NORTHERN STATES POWER COMPANY

PRAIRIE ISLAND NUCLEAR GENERATING PLANT
Docket Nos. 50-282 License Nos. DPR-42
50-306 DPR-60

Information Relating to Fire Protection Modifications

Information Relating to Fire Protection Modifications

FIGURE 4

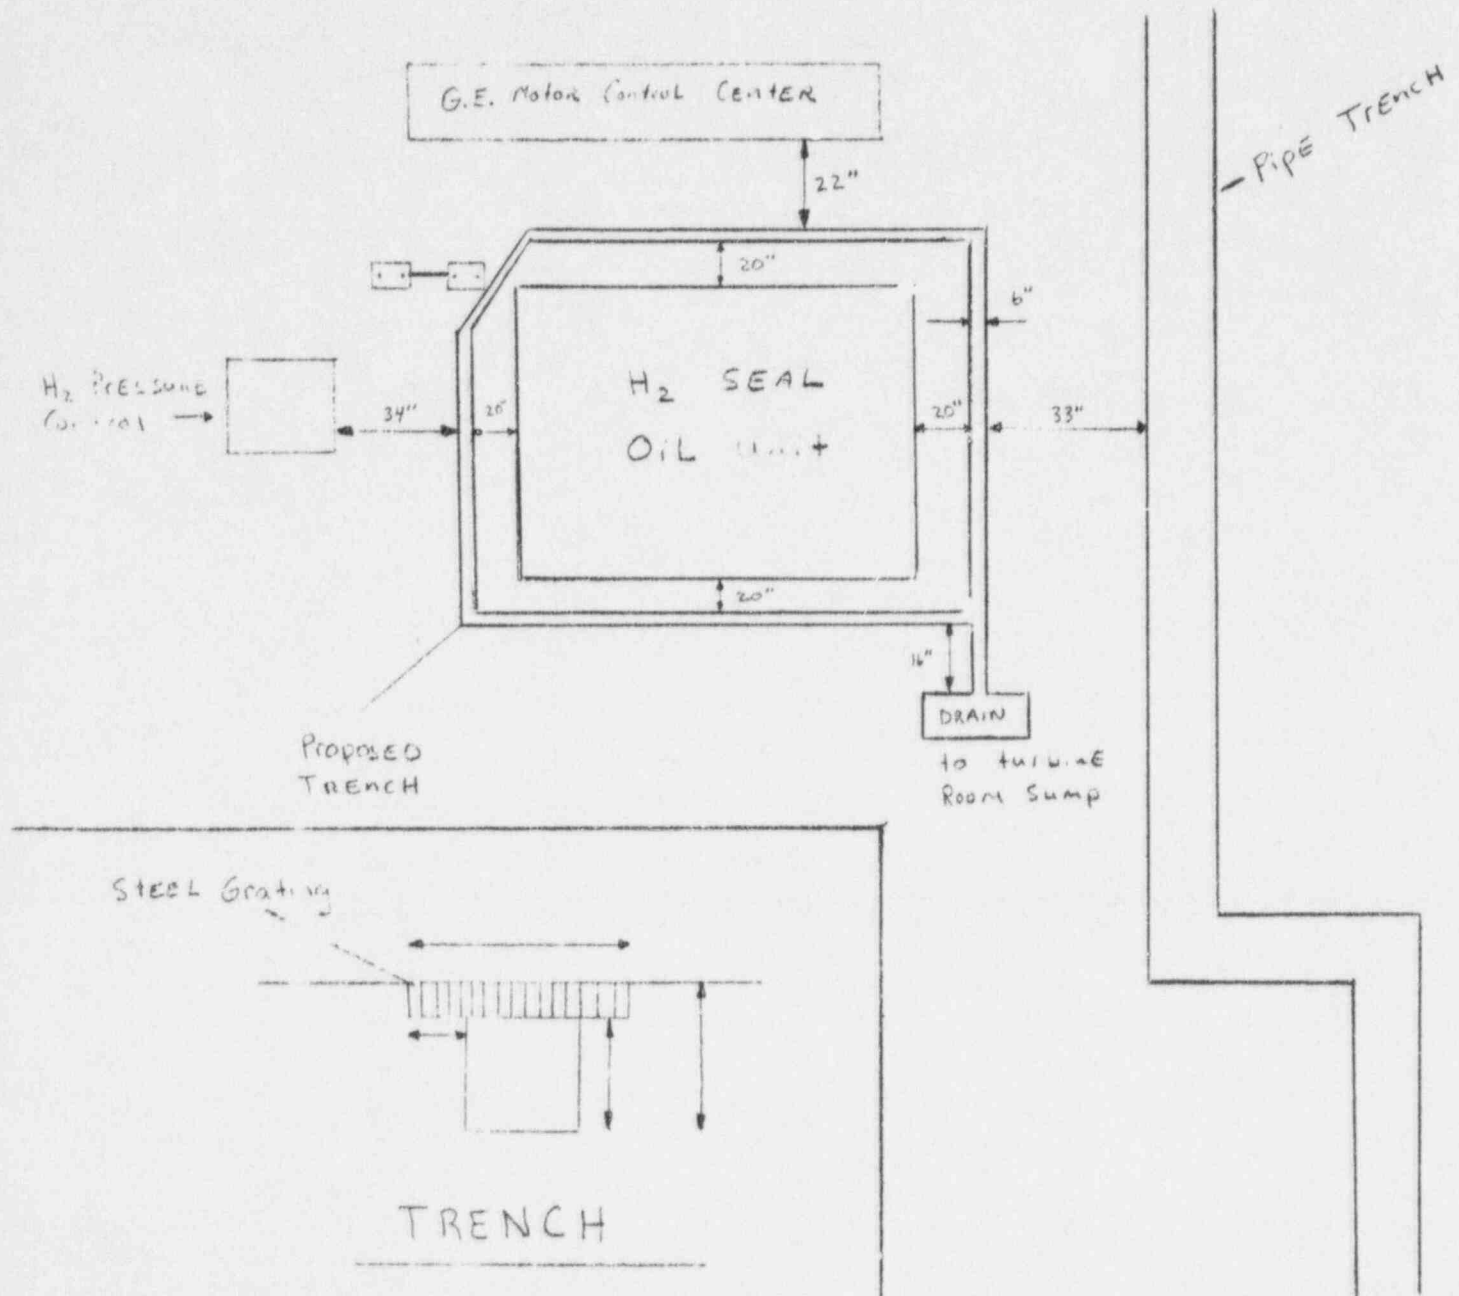
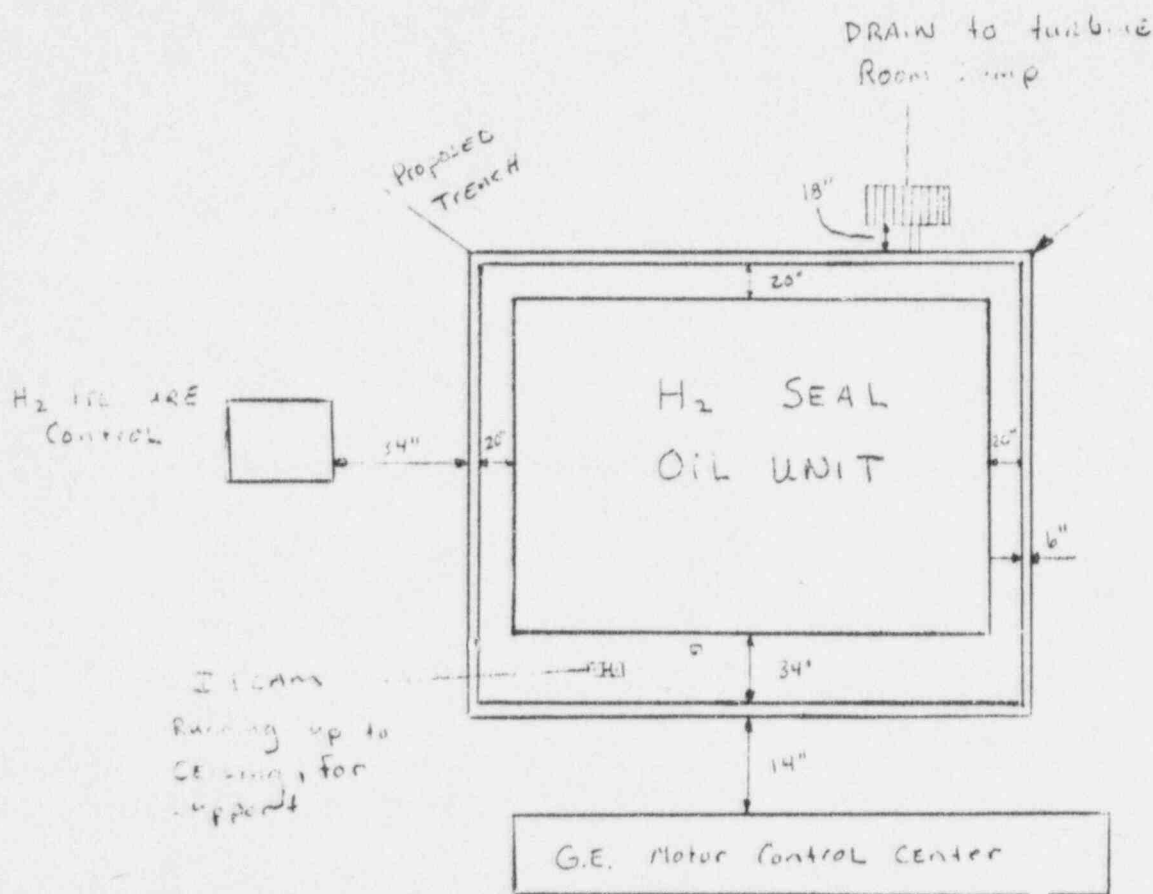
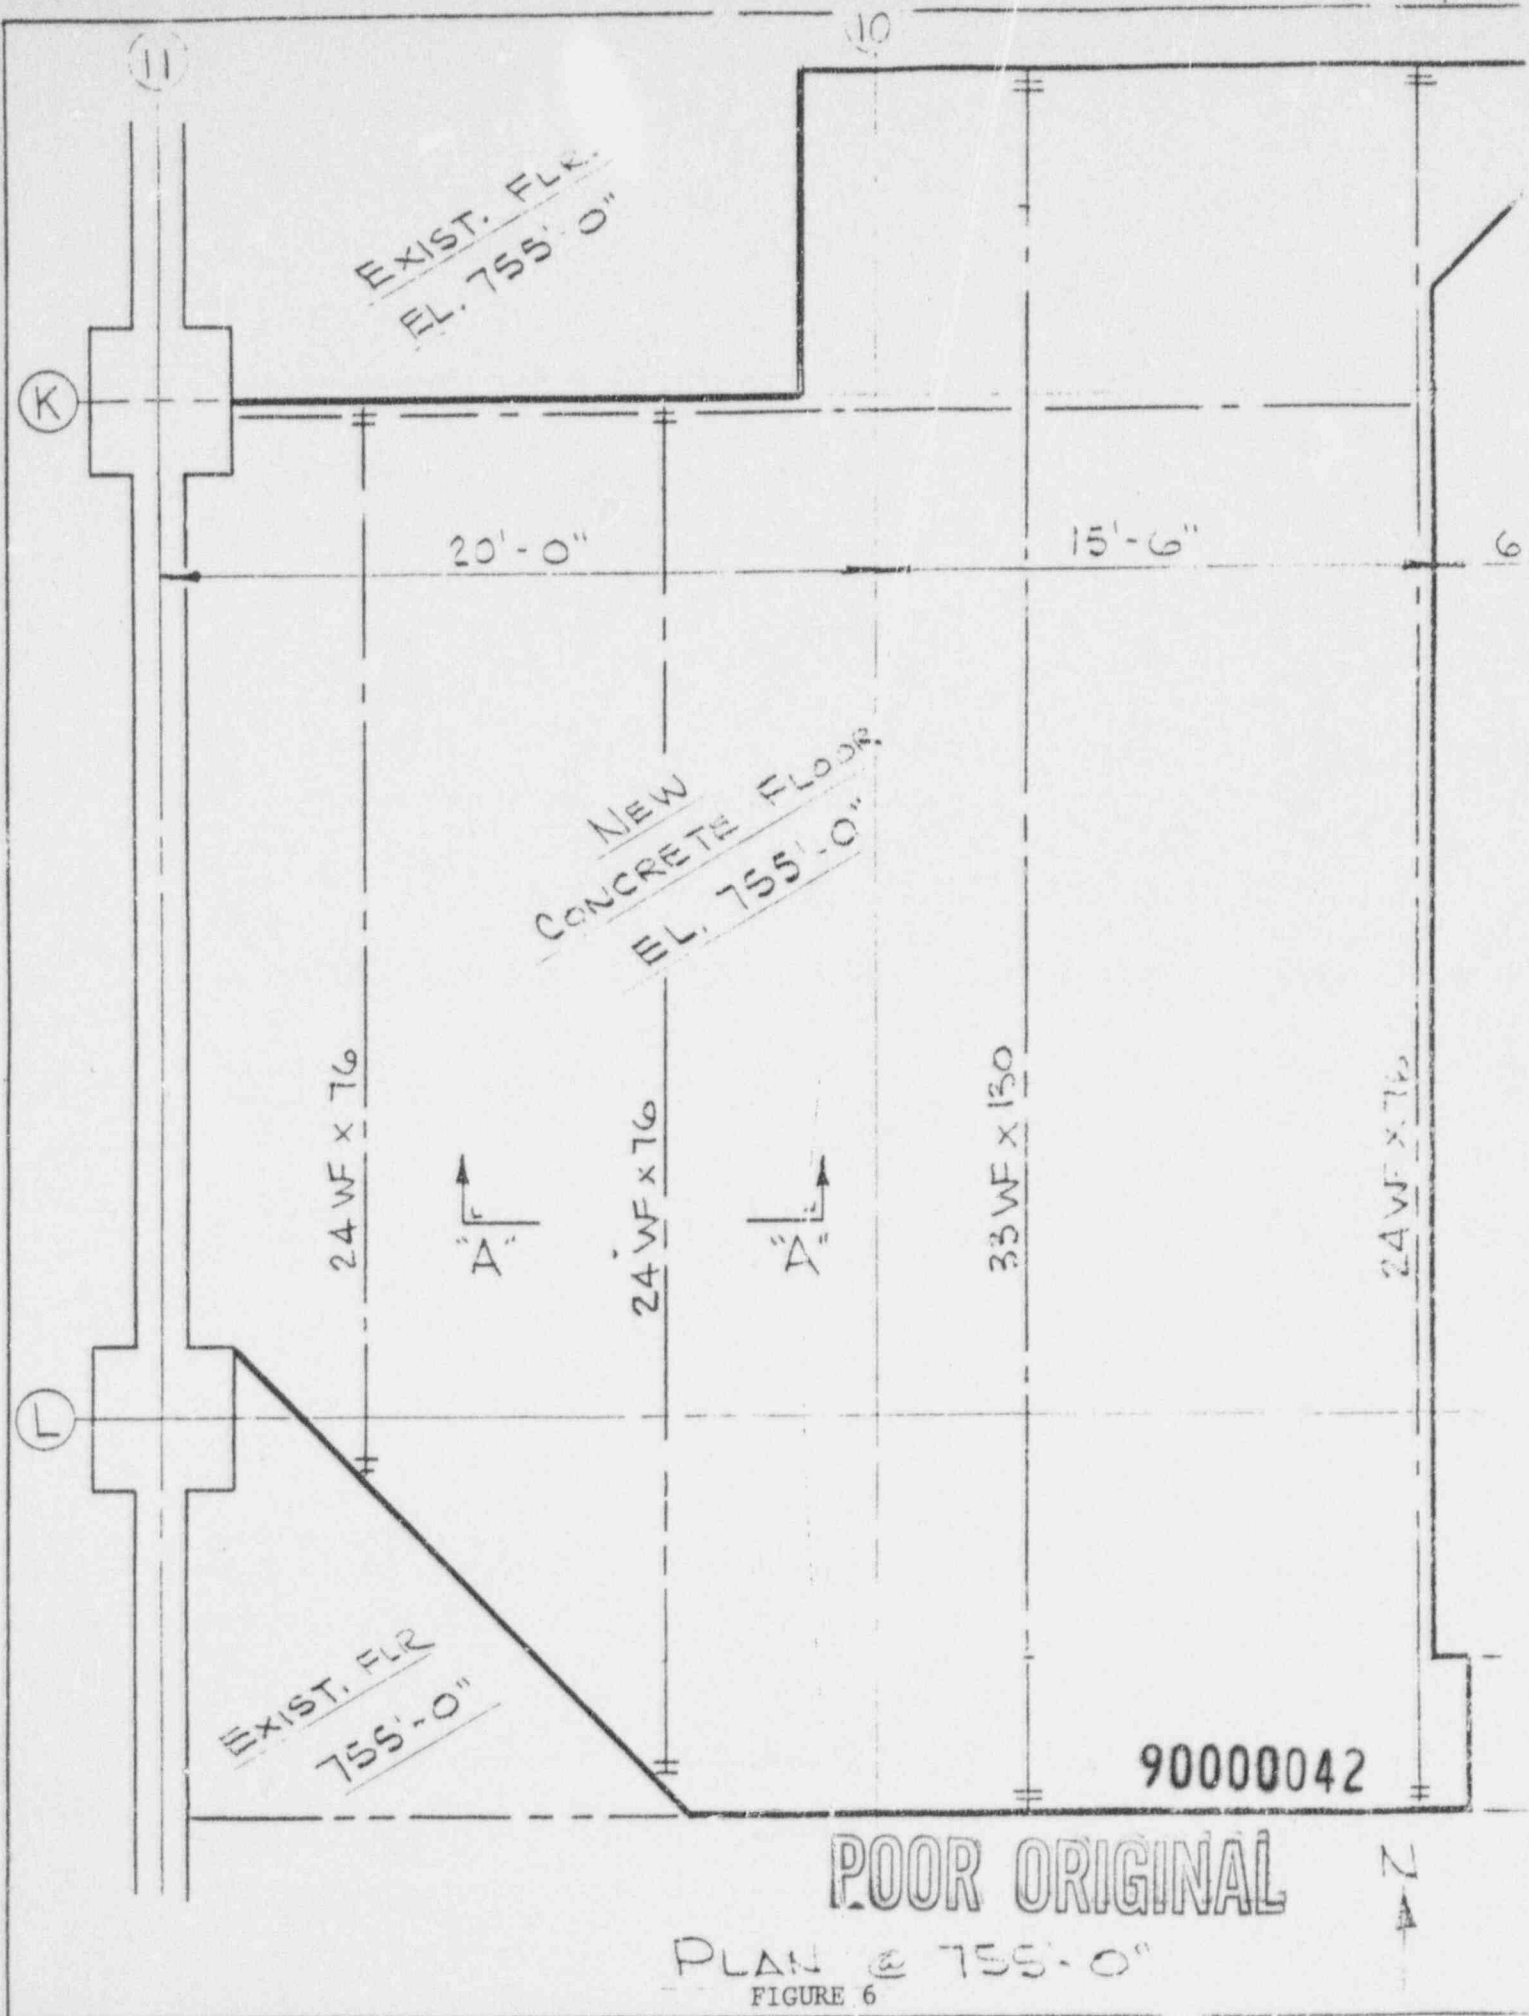
3.1.4 (1) Hydrogen Seal Oil Unit Trench

We propose to cut out the concrete around each seal oil unit to form a 6" x 6" trench. This trench will have a grating surface and a slight grade drop to the turbine room drain. (See Figures 3, 4, and 5.) All turbine room drains go to their respective unit sumps located in the condenser pits. The sumps have oil absorbent pillows in them. The sumps are inspected monthly with pillows replaced as necessary.

PRAIRIE ISLAND NUCLEAR GEN. STATION

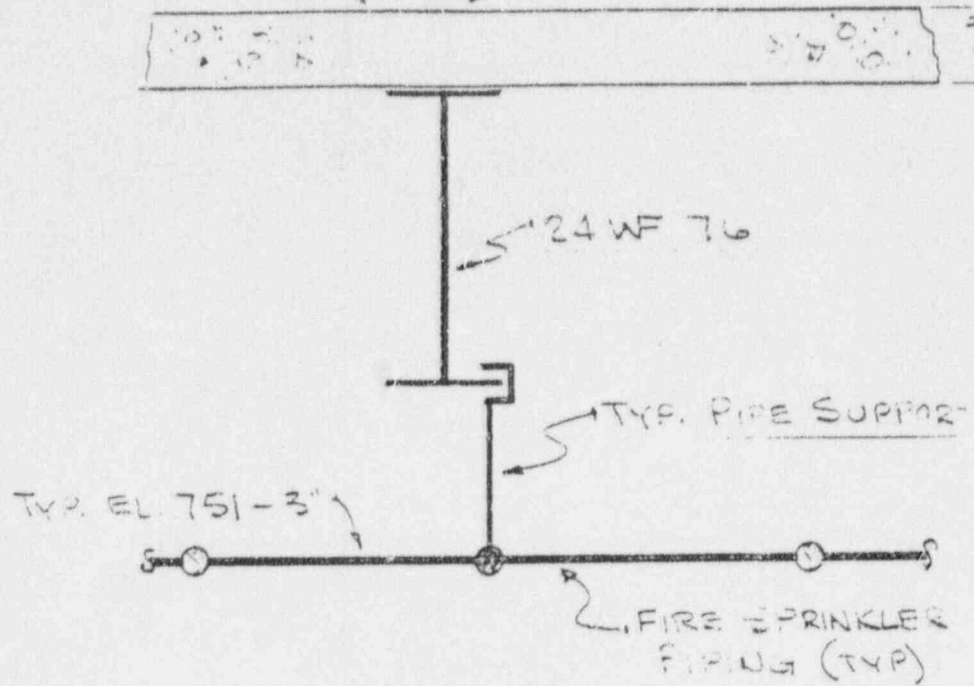
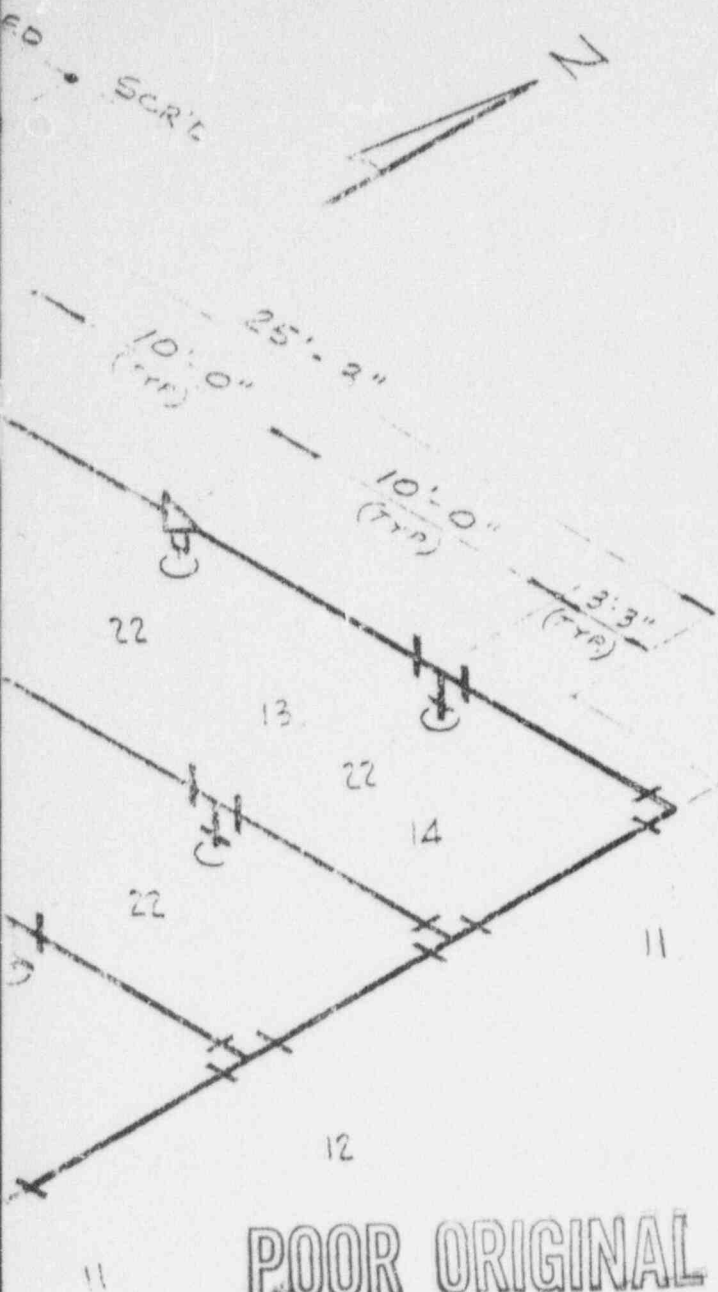
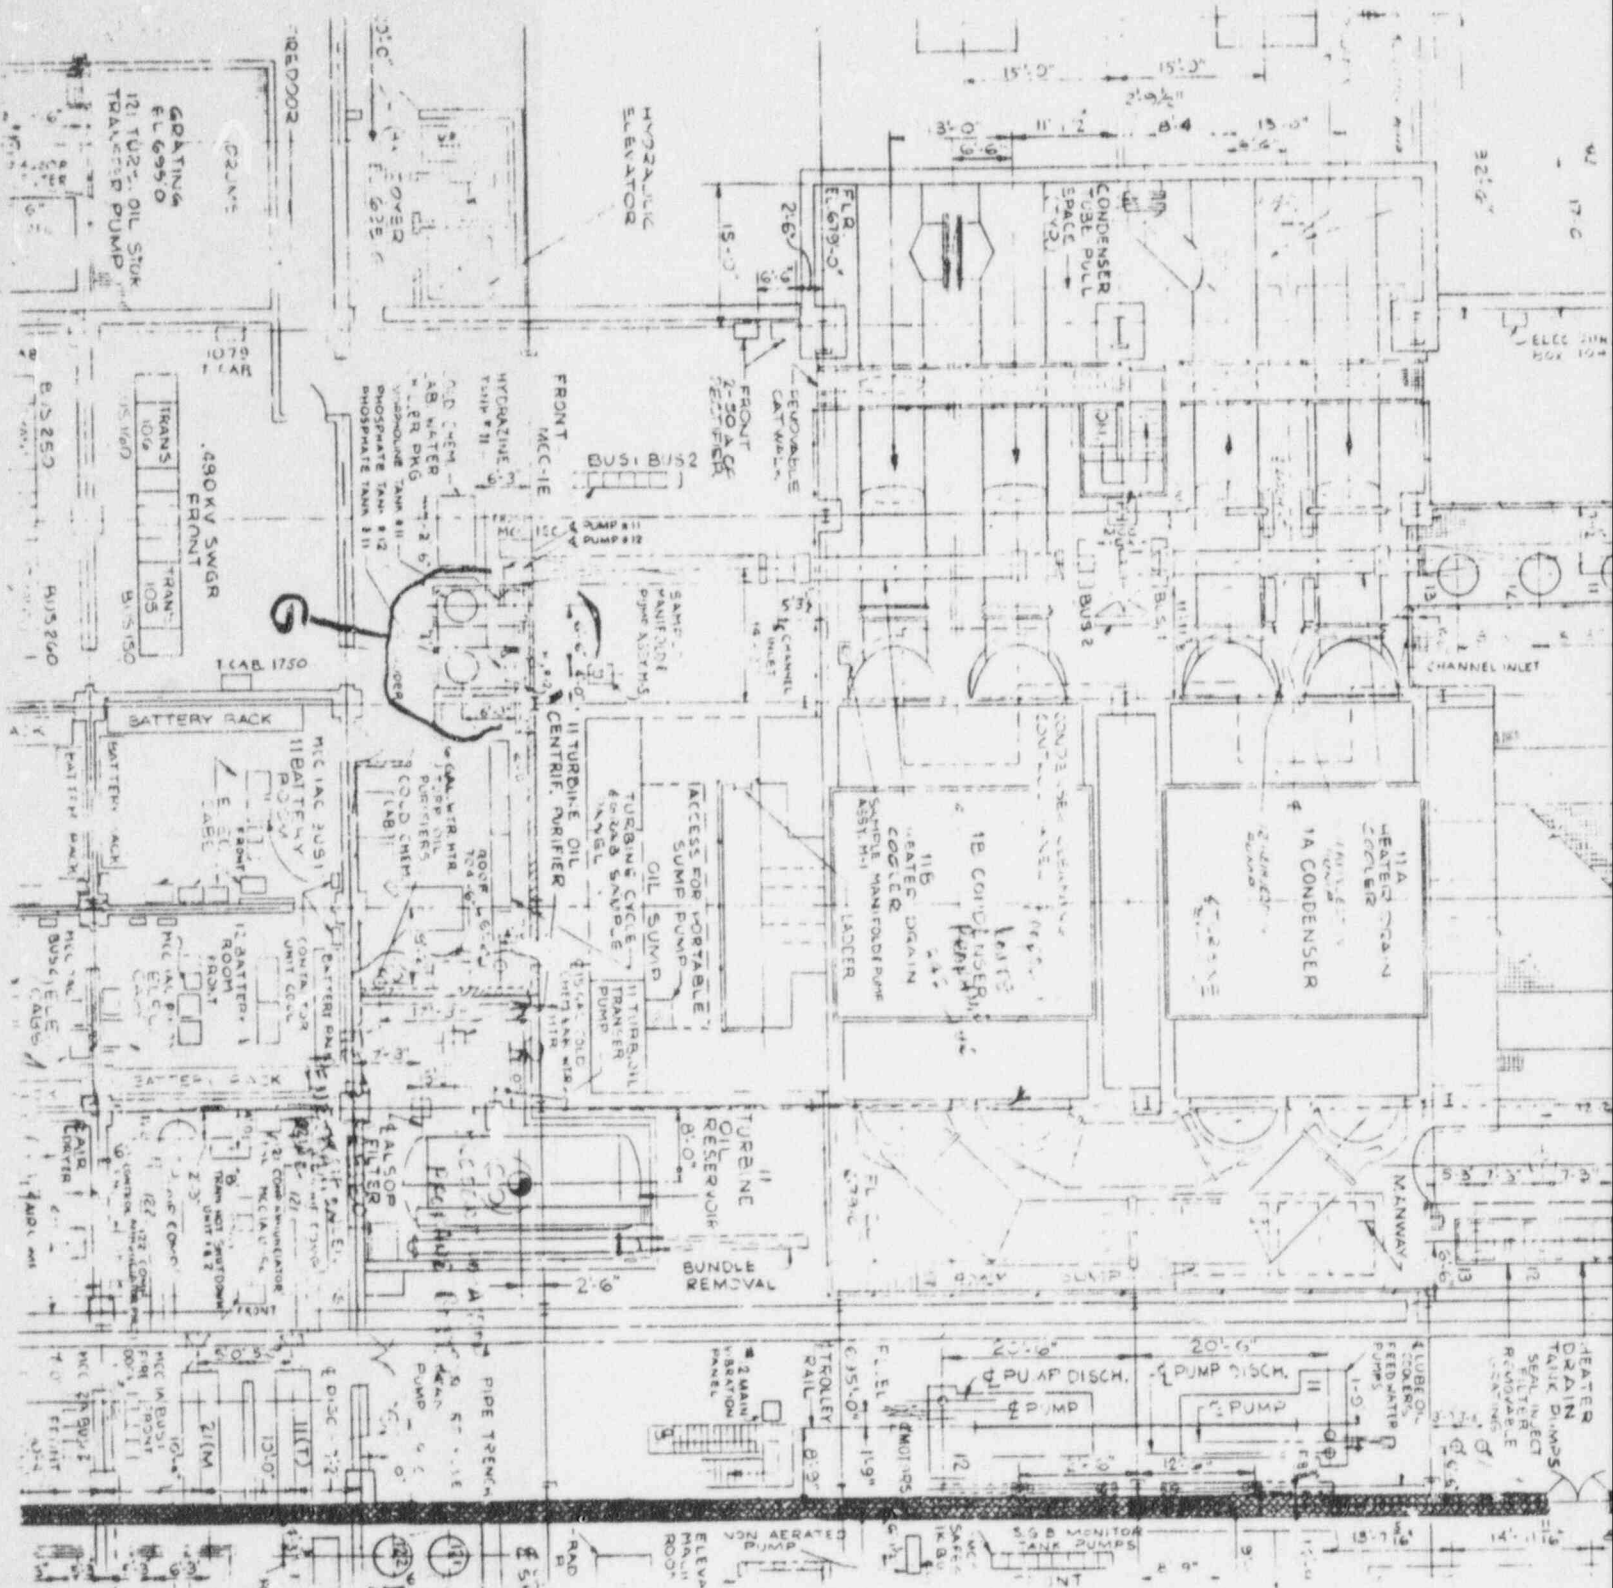
3.1.4 (10) Hatch Area Sprinkler System

The proposed sprinkler addition is shown on Figures 6 and 7. The installation has the approval of American Nuclear Insurers. Material has been received and prefabrication started. Final installation will be completed following NRC Staff approval of the design. During the January, 1980, Unit No. 2 outage, we will tie the system into the main fire header in the Unit No. 2 side of the Auxiliary Building. This must be done to permit completion by October, 1980.
